## **MARIAN ELMORE SUBDIVISION**

APPLICATION NUMBER 8 DATE October 17, 2013

REQUEST Subdivision

# DETAIL SITE PLAN

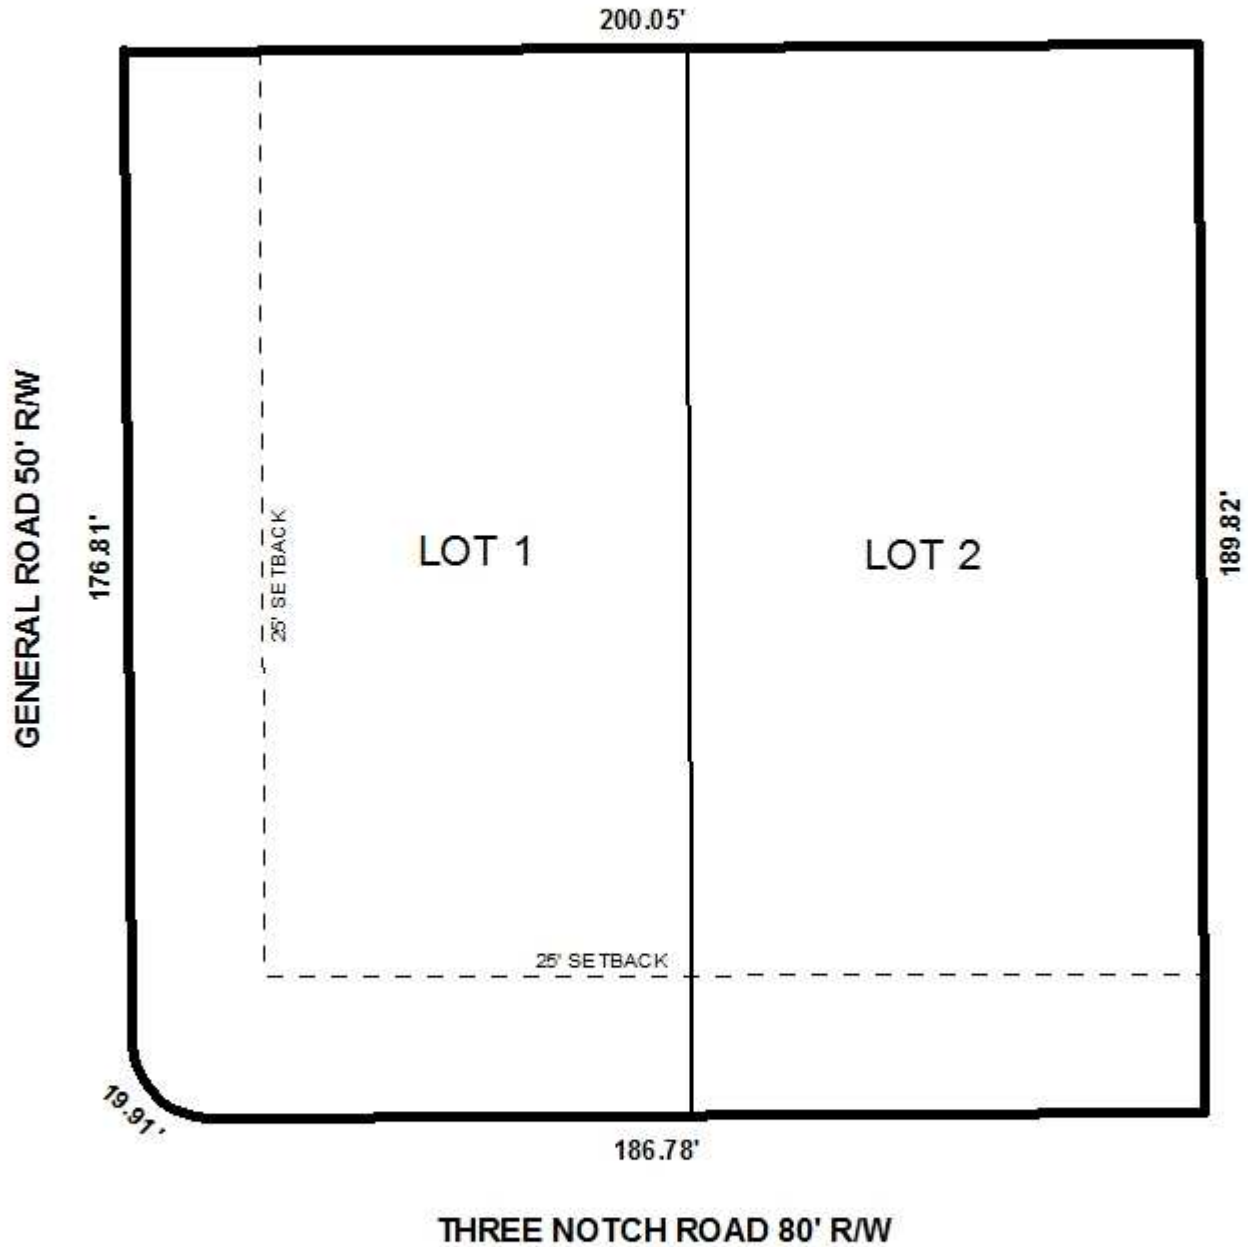
The proposed Lot 1 has frontage on General Road, a minor street that provides approximately 200 feet of curb and gutter. General Road is depicted with an adequate 50' right-of-way, and no additional dedication would be required. Both proposed Lot 1 and Lot 2 have frontage on Three Notch Road, which is shown as a major street on the Major Street Plan component of the Comprehensive Plan. The preliminary plat submitted indicates that Three Notch Road has a current 80' right-of-way along the property; however, a minimum of 100' right of way is required by the Major Street Plan. Therefore, dedication of sufficient right-of-way along Three Notch Road to provide 50' from centerline will be required.

Currently, the proposed Lot 1 and Lot 2 are developed with one curb cut each to Three Notch Road. Lot 1 also has three curb cuts to General Road. Because access management is a concern, Lot 1 lot should be limited to one curb cut onto General Road, with the size, design and location

The preliminary plat depicts the 25-foot minimum building setback line from the right of way line of Three Notch Road and General Road. As dedication of right-of-way will be required, this should be adjusted on the plat to depict the revised dedicated frontage along Three Notch Road. The corner radius on General Road and Three Notch Road should also be adjusted to reflect the required dedications.

While this is a subdivision application there is a Zoning Ordinance related issue that should be addressed. The proposed Lot 2 illustrates two existing structures on a single building site, which is not allowed by the Zoning Ordinance without an approved Planned Unit Development (PUD). Because the site is located within the city, the Zoning Ordinance requires a (PUD) to allow multiple structures on a single site. If approved, it should be noted the site would create a zoning violation, thus a PUD application should be required.

- 1) revision of the plat to reflect dedication of sufficient right-of-way to provide 50' from the centerline of Three Notch Road;
- 2) submission of a Planned Unit Development application for Lot 2;

- 3) placement of a note on the Final Plat stating that Lot 1 and Lot 2 are limited to one (1) curb cut each to Three Notch Road, and Lot 1 is limited to one (1) curb cut to General Road with the size, location, and design of all curb cuts to be approved by Traffic Engineering and conform to AASHTO standards;

- 4) adjustment of the 25-foot minimum building setback line to be measured from the dedicated right-of-way along Three Notch Road;
- 5) revision of the corner radius on General Road and Three Notch Road should be illustrated to reflect the required dedication;

- 6) the labeling of lots 1 and 2 in acres and square feet should be retained and provided on the Final Plat;
- 7) placement of a note on the final plat stating that approval of all applicable Federal, state and local agencies is required for endangered, threatened or otherwise protected species, if any, prior to the issuance of any permits or land disturbance activities;
